NEWMAR CORPORATION

TECHNICAL SERVICE BULLETIN

TSB #
194

SUBJECTS: 1) Gussets on Cradle for the Bell Crank and Idler Crossmember

Adding Gussets to the Cradle Steering Box Crossmember

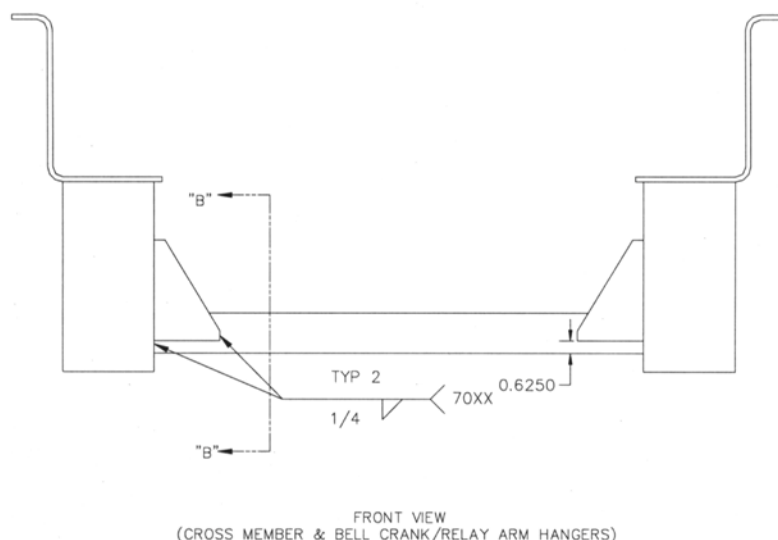
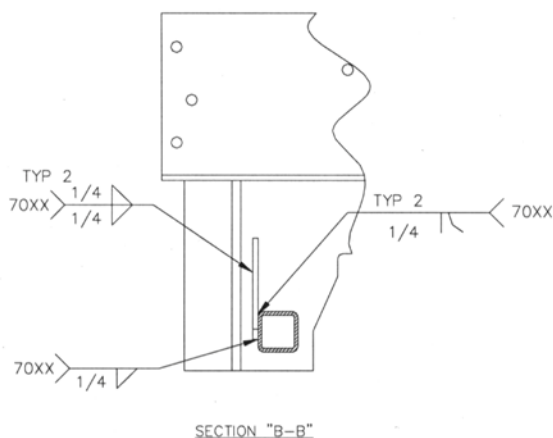
Add #8516 Gussets to bell crank and idler arm crossmember connections.

1. Clean and remove all dirt, oil, undercoating and road tar from the weld area where the crossmember is connected to the steering component brackets.
2. While turning the wheels from left to right, check weld joints (both sides) for cracking. If no cracks are observed, proceed with the installation of the gussets.

5. If the weld is cracked but not all the way around such the end of the crossmember is not separated for the steering brackets, repair the weld as follows:

- b) Repair the joint by welding the crossmember to the steering bracket using AWS 70,000 tensile weld wire (gas shielded) or electrode (flux shielded). Remove weld spatter and slag as required.

1. Clean area where gusset is to be installed. All dirt, oil, undercoating and road tar is to be removed from the area where the gussets are to be installed by welding.
2. Locate Gussets into position as shown in the drawing below. Hold the gussets in position using "c-clamps, weld clamps, or similar device.
3. Weld the gussets in place per the drawing below.
4. Once the gussets are cool, repaint and re-undercoat as required the area of the repair.
